Entergy Nuclear Vermont Yankee, LLC  
Entergy Nuclear Operations, Inc.  
185 Old Ferry Road  
Brattleboro, VT 05302-0500

Docket No. 50-271  
BVY 05-072  
TAC No. MC0761

Subject: **Vermont Yankee Nuclear Power Station  
Technical Specification Proposed Change No. 263 – Supplement No. 30  
Extended Power Uprate – Response to Request for Additional Information**

**Figure SRXB-A-6-1  
Cycle 24 MFLCPR**

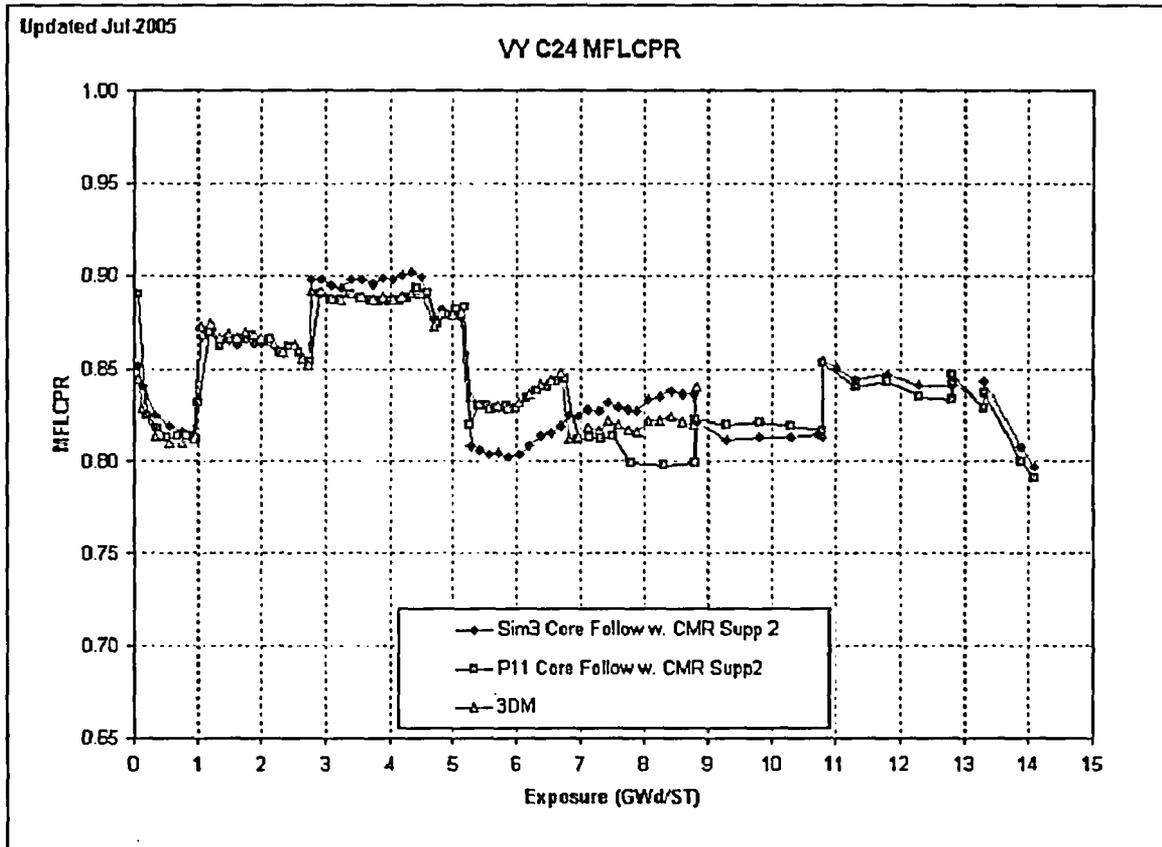
SIMULATE-3 shows good agreement with GNF methods as shown in *Figure SRXB-A-6-1* and there is substantial margin where the codes do not agree. The data points beyond the last 3DM point represent the as designed expected values for each thermal limit, in this case the Cycle 24 (current cycle) Cycle Management Report (CMR), Supplement 2.

**Figure SRXB-A-6-2**  
**Cycle 24 Pin Power Reconstruction Based MFLPD**

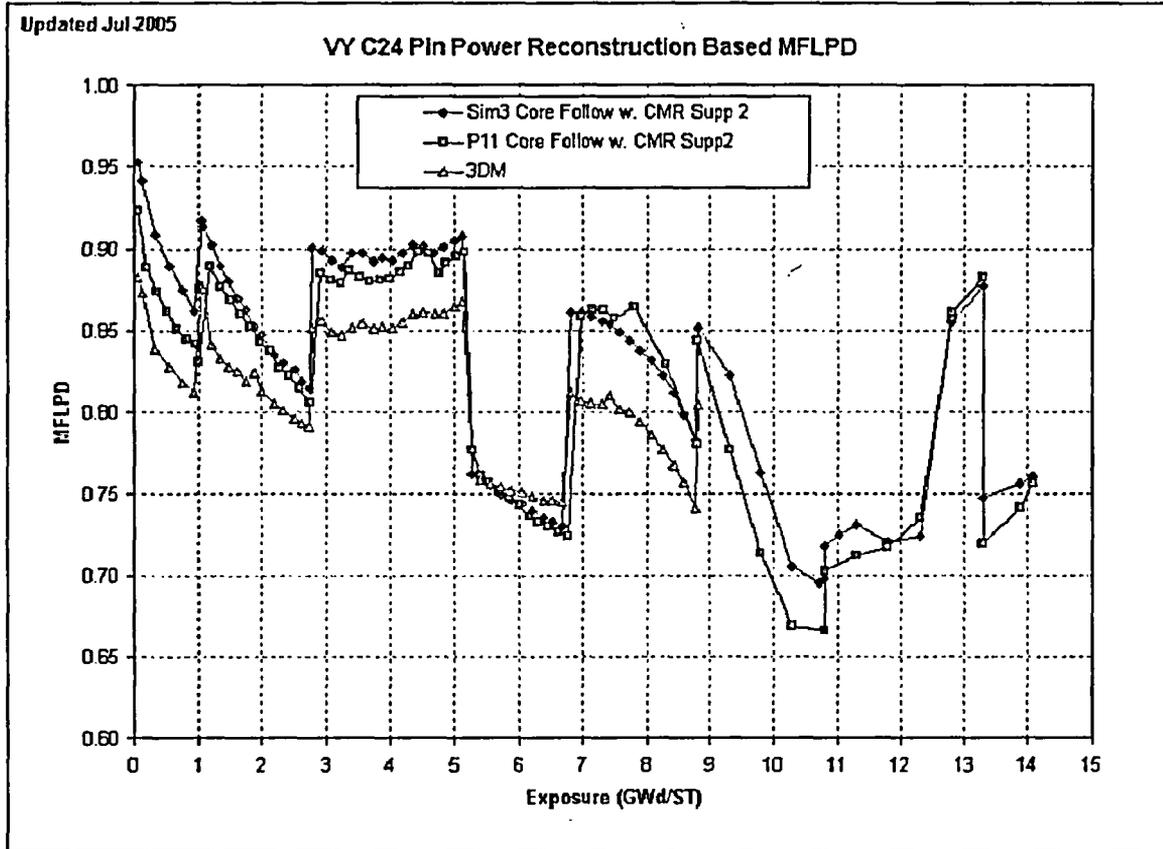
SIMULATE-3 uses its own pin power reconstruction module to determine MFLPD. As in *Figure SRXB-A-6-2*, in most cases, SIMULATE-3 and P11 calculate a larger and more conservative MFLPD than is representative in actual 3DM online operations, but the two offline codes agree relatively well.

**Figure SRXB-A-6-3 – Cycle 24 MAPRAT**

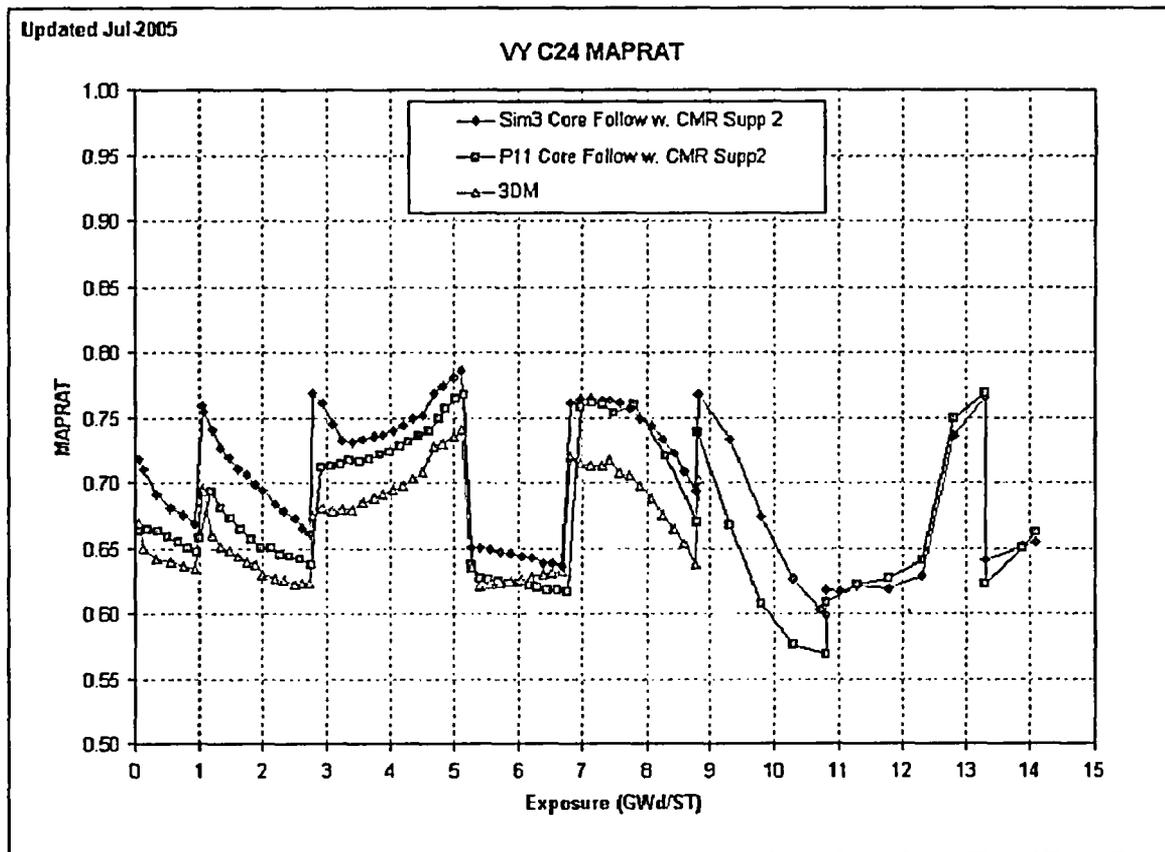
MAPLHGR is a nodal parameter and requires no additional SIMULATE-3 module for its calculation. SIMULATE-3 and P11 have a fairly consistent bias over 3DM as shown in *Figure SRXB-A-6-3*. MAPRAT is typically the least limiting thermal limit at VYNPS.

Figure SRXB-A-6-4  
 Cycle 24 TIP Comparison Data

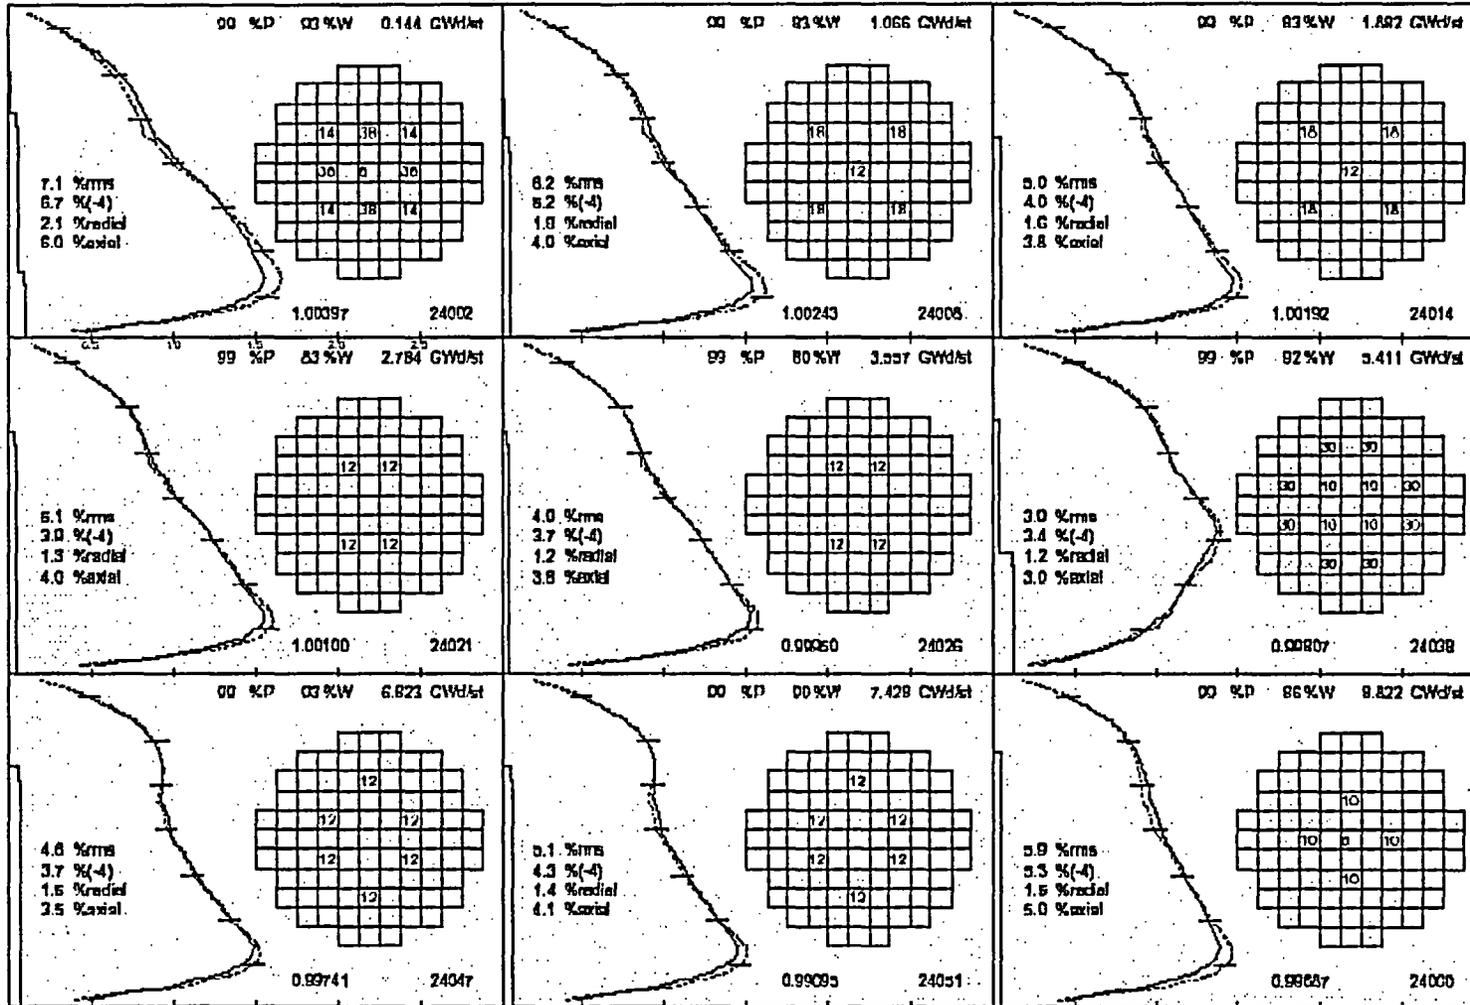
The following TIP output, *Figure SRXB-A-6-4*, depicts the comparison for VYNPS Cycle 24. The dashed line represents SIMULATE-3 and the solid line, 3DM. The radial, axial, and nodal RMS error values are calculated for each combined core average TIP. Any larger than expected

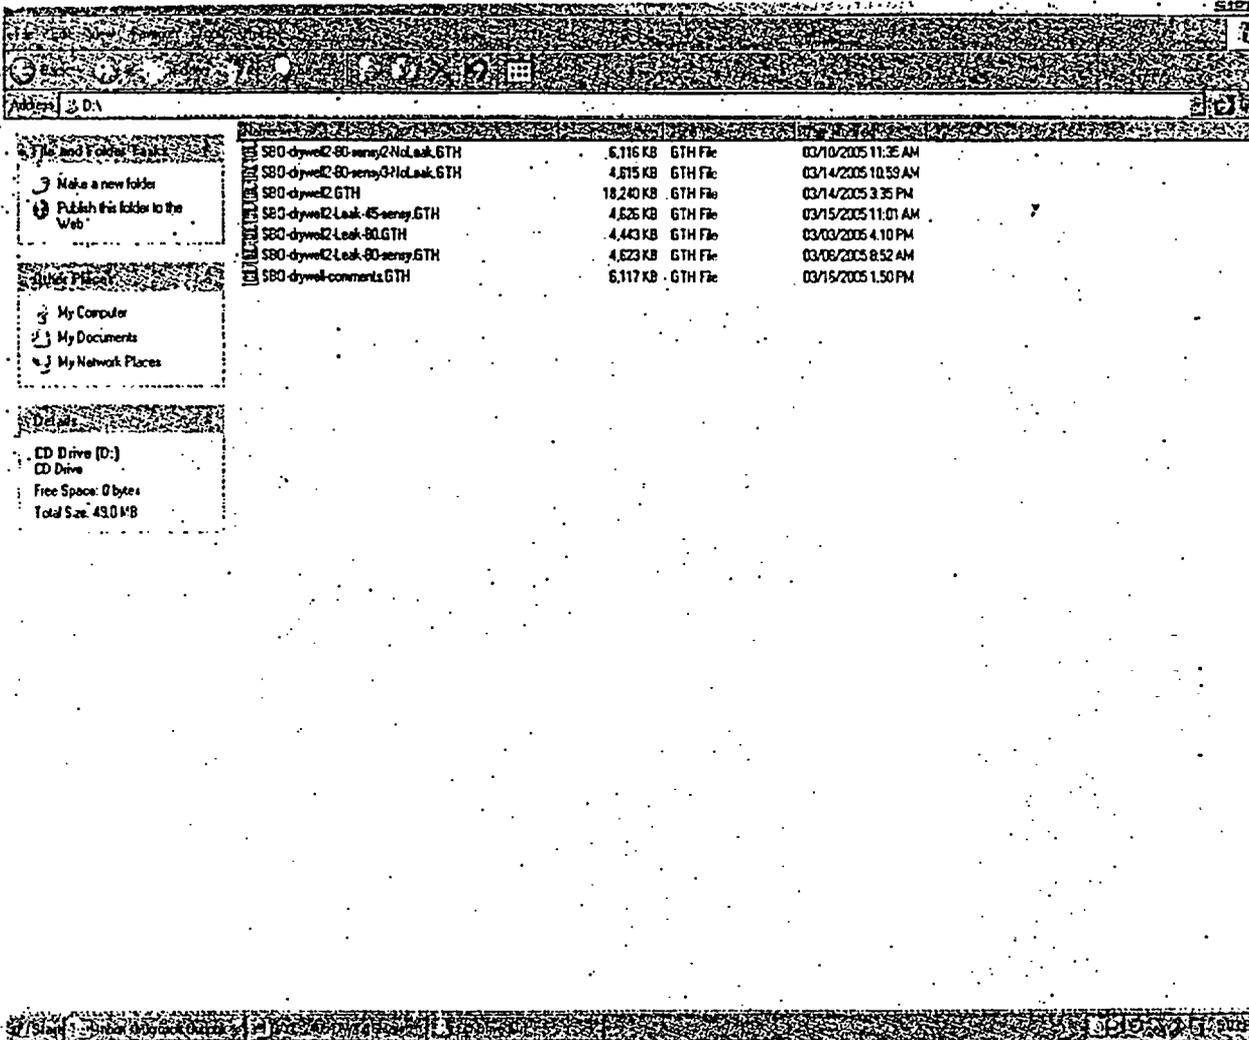
- In the GOTHIC Input Deck, Thermal Conductor #16, Concrete Shield, a surface area value of 2108 ft<sup>2</sup> was used. A value of 2068 ft<sup>2</sup> was given in the text of VYC-2405 (Section 5.4). Both of these numbers are found on page 35 of VYC-1850, Rev. 1 for OPL-4A preparation. The larger value (2108 ft<sup>2</sup>) is for total surface area, the smaller value (2068 ft<sup>2</sup>) subtracts the "Slots." The value used in VYC-1850, Rev. 1 CCN-01 (OPL-4A, Resolved for Analysis) uses the 2068 ft<sup>2</sup> value. Please discuss this in the analysis and determine which value to use, any sensitivities, etc.

*Case 5 addresses this.*
